Application No. 10/635,926

AMENDMENTS TO THE DRAWINGS

REMARKS

Fig. 2

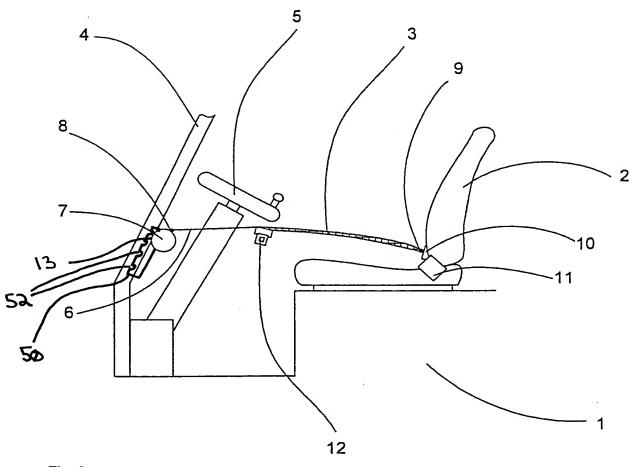
Applicant encloses herewith a proposed drawing correction to Fig. 2 showing the proposed changes in red ink. Fig. 2 has been amended to specifically show the rail and notches discussed in the specification at paragraph 0024. Approval of the proposed drawing correction to Fig. 2 is respectfully requested.

The drawings were objected to for not specifically showing the "adjustable component" claimed in claims 5, 13, 14, and 15. In response, Applicant encloses herewith a proposed drawing correction to Fig. 2 to illustrate the adjustable component. Specifically, Fig. 2 has been amended to show the rail 50 with catches or notches 52 discussed in the specification at paragraph 0024.
